# 201 FOLSOM STREET

## FINAL ENVIRONMENTAL IMPACT REPORT

SAN FRANCISCO PLANNING DEPARTMENT  
2000.1073E

1. Comment Letters
2. Transcript of Draft EIR Public Hearing

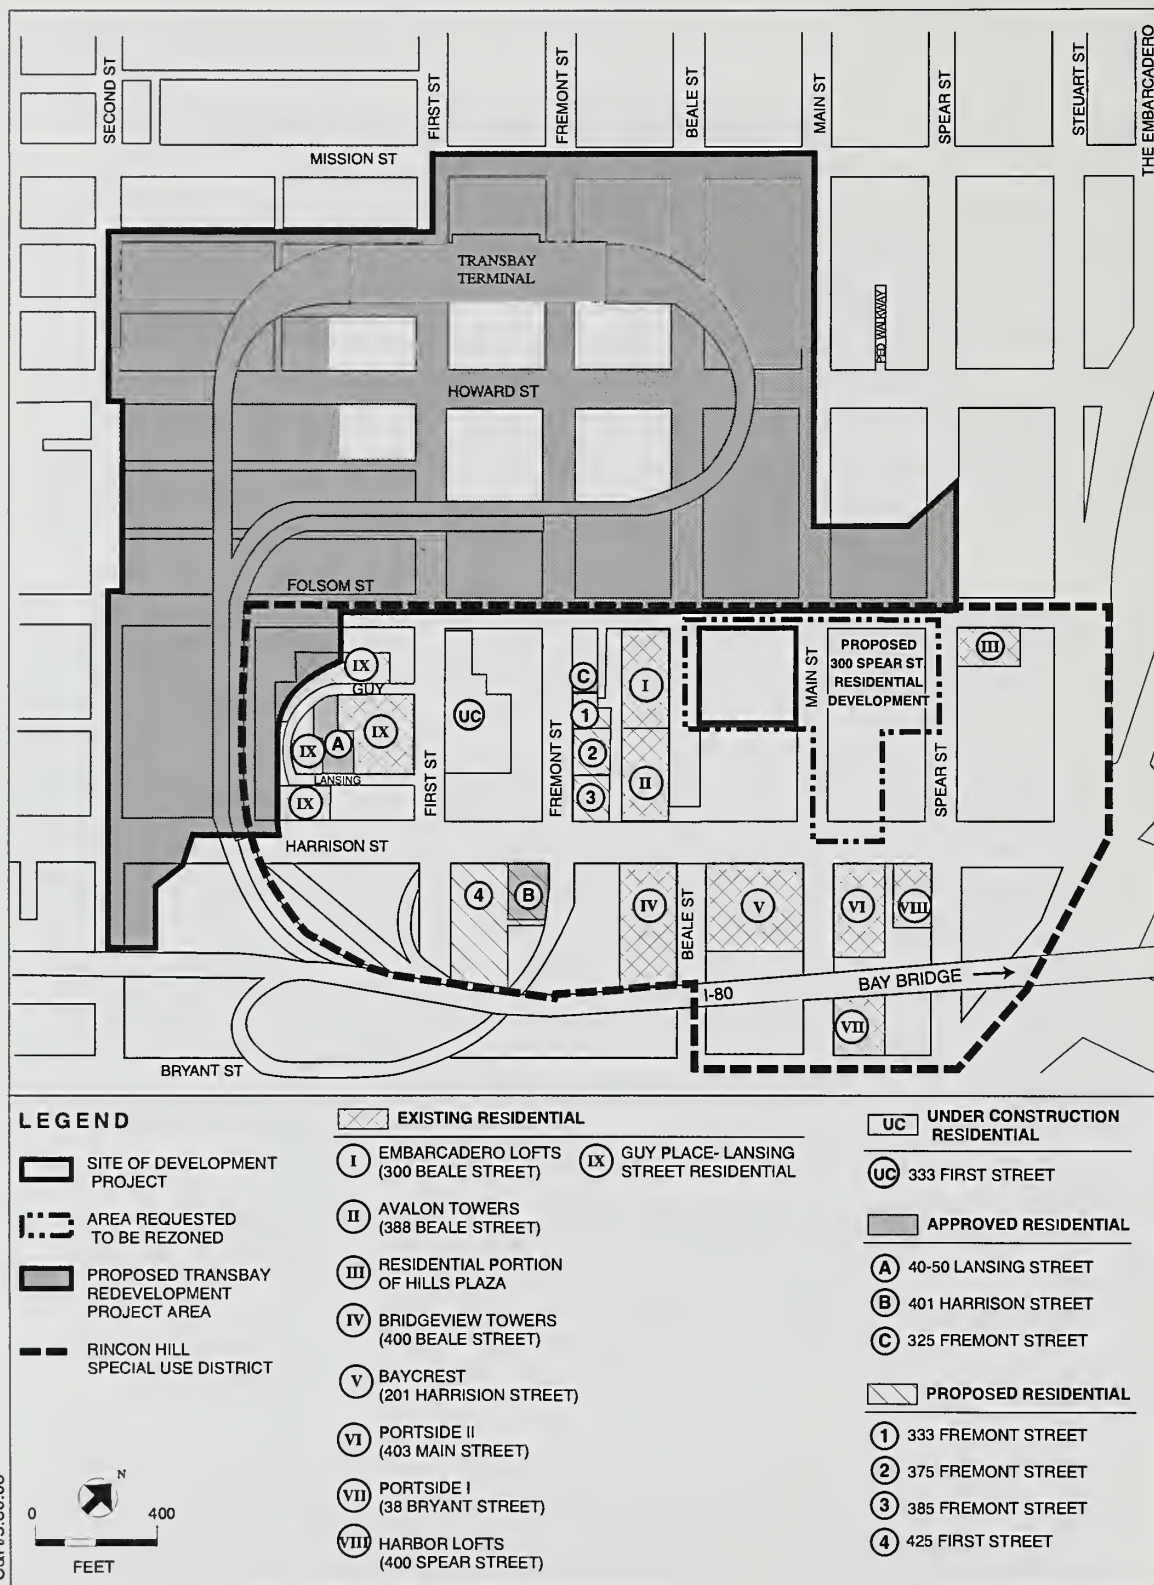
Residential developments in the near and mid-vicinity (within three to four blocks) of the requested rezoning area are the predominant uses to the south and west. They include Embarcadero Lofts (at 300 Beale Street), Avalon Towers (at 388 Beale Street), an approved residential development at 325 Fremont Street, **proposed residential developments at 333 Fremont Street, 375 Fremont Street, and 385 Fremont Street**, a residential development under construction at 333 First Street, **existing residential buildings surrounding Guy Place and Lansing Street**, and an approved residential development at 40-50 Lansing Street west of the requested rezoning area across Beale Street; and Harbor Lofts (at 400 Spear Street), **Portside I (at 38 Bryant Street)**, Portside II (at 403 Main Street), Baycrest (at 201 Harrison Street), Bridge View Towers at 400 Beale Street, an approved residential development at 401 Harrison Street, and a **proposed residential development at 425 First Street** south of the requesting rezoning area across Harrison Street. (See Figure 21: Existing, Under-Construction, Approved, and Proposed Residential Developments in Project Vicinity.)

A sentence has been added to the end of the paragraph at the end of p. 60, as follows:

Immediately west of First Street, about two blocks west of the development site, there are mainly low-rise multifamily residential buildings surrounding Guy Place and Lansing Street, with some corner and interior commercial and industrial uses, including a gas station. **However, an 81-unit residential development has been recently approved at 40-50 Lansing Street.**
